STAFF REPORT 4/20/2022

SUBJECT: Tripoli Mixed-Use Project (Continued from April 13, 2022)

SPECIFICS: Change of Zone (CZ) 22-01, Conditional Use Permit (CUP) 351, Architectural Review (AR) 22-04 to amend the Official Zoning Map by adding the PUD (Planned Unit Development) Overlay Zone on 2.8 acres of vacant C-G (General Commercial) zoned property for a mixed-use development consisting of 108 apartment units and 2 retail units. The site is located at the northeast corner of Cesar Chavez Street and Bagdad Avenue (APN# 778-081-003 and -001) Applicant: Chelsea Investment Corporation

Figure 2: Site Plan

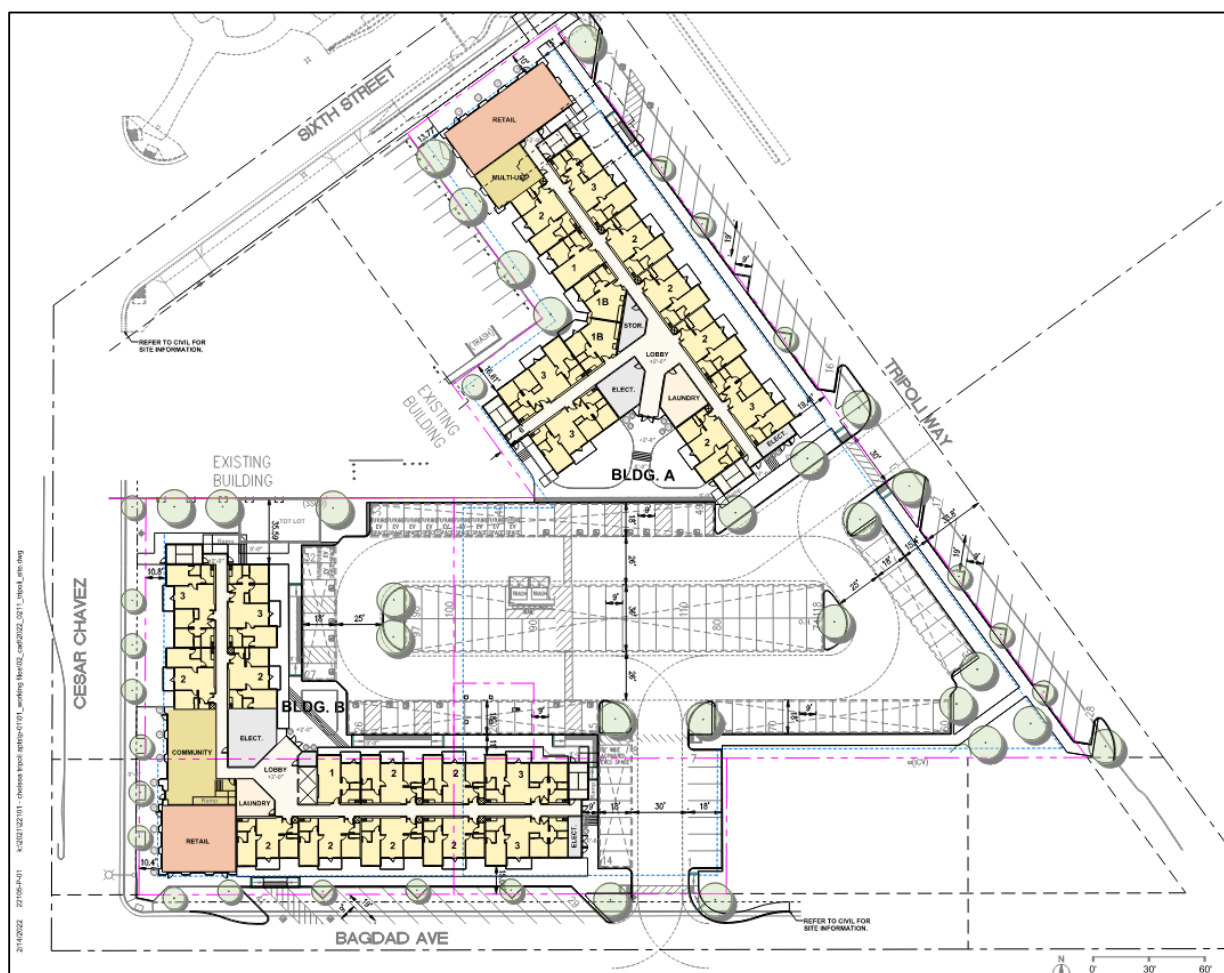
A 652 sq. ft. multi-purpose building and laundry room is proposed on the first floor. The main entrance and lobby is accessed from the parking lot, in addition to 3 other access points. Access above the first floor is by three proposed staircases and no elevator is proposed. Staff has requested that space between the west building elevation and property line be configured to improve safety and opportunity for usable common area for residents and customers of the retail space.

The parking serving the site is provided with one large on-site parking area consisting of 118 parking spaces and is accessed by driveways from Bagdad Avenue and Tripoli Way. Parking based on 120,873 sq. ft. of gross floor area, would require 362 spaces in the Pueblo Viejo Revitalization Plan. The applicant proposes 118 onsite parking spaces and 41 on-street parking spaces. The Pueblo Viejo Revitalization Plan draft development standards allow for on street parking to be counted toward required parking if within 500 feet of the main entrance of the development. Senate Bill 35 allows affordable housing development within ½ mile of public transit to be exempted from parking standards. With the application of density bonus law, only 61 parking spaces would be required or a surplus of 97 parking spaces. Staff is supportive of allowing the development to utilize on-street parking to count towards satisfying parking requirements,
